RE: PLANNING APPLICATION 2016/6483/P

We are writing regarding planning application 2016/6483/P (31 Briardale Gardens).

Our comments are as follows (please refer to the marked up PDF of the plans attached to this letter):

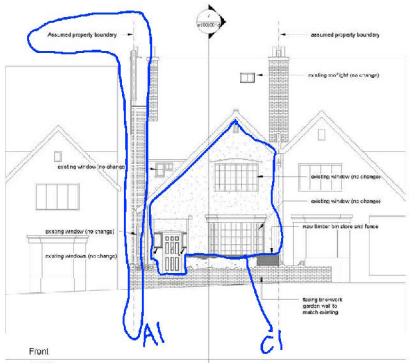
Incorrect boundary (mark up A)

The plans show an 'assumed boundary'. These differ between the elevations shown on the plans. For avoidance of doubt, the boundary ends at the wall, as shown in mark up A2. We, as the owners of 33 Briardale, do not own any part of the wall of 31 Briardale, therefore the boundary shown in mark up A1 is incorrect. This is consistent with the location map, site location plan and other documents.

8 Roof Plan
1 : 100

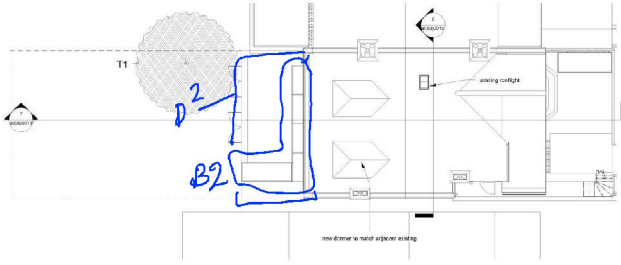
Need for etching on roof lights (mark up B)

Ms Davis has raised the need for etching of the proposed roof lights in her response. The etching needs to extend to all of the roof lights (as shown in mark up B), given the proximity and visibility of these from our bedroom windows.

9 Basement Plan
1 : 100

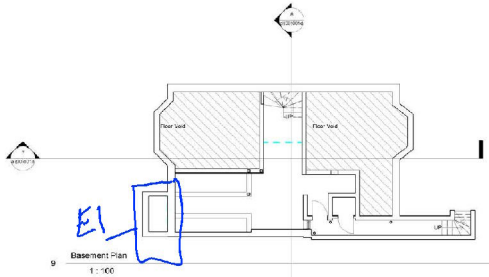
Basement void (mark up E)

The nature of the basement space circled at mark up E is unclear. We have been reassured that this will not contain plant and machinery and we trust that it will simply be a void. We have explained previously the issues and prohibitions (structural and legal) with any basement works.
